BOARD OF SELECTMEN

To Zoning Board of Appeals
RE: Summer Street 40B application

Applicant responses in red below. April 30, 2020

Units per Acre Surrounding area *

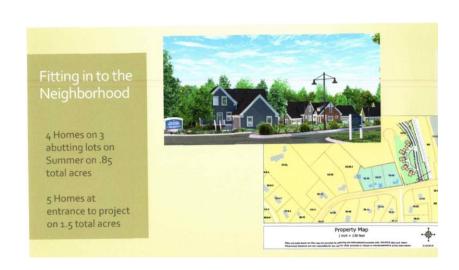
The project as proposed is not in keeping with the character of the neighborhood. The Select Board recognizes that, as expressed in the State's Design Guidelines, 40Bs typically introduce greater density into a neighborhood than what currently exists or is allowed by zoning. But, we also support the assertion in the Guidelines that "it is important to mitigate the height and scape of the buildings to the adjoining site...it is particularly important to consider the

unit portion is far denser than what exists in the surrounding neighborhood. The siting of the buildings on the property, roof lines, and architectural style must be readdressed to more thoughtfully fit into the surrounding context.

The applicant has worked hard to ensure the Cedars is in keeping with the character of the neighborhood. For instance, the Cedars density is in keeping with the neighborhood as the overall density of the Cedars at 7.62 units/ buildable acres is less dense then the 7.88 units per acre of properties immediately surrounding the South Walpole Common which is the gateway to the South Walpole neighborhood (see attached map and density chart). Taken on their own, the five units at the entrance of the project at 3.33 units/acre are less dense than the three adjacent properties immediately to the west at a density of 4.7 units per acre.
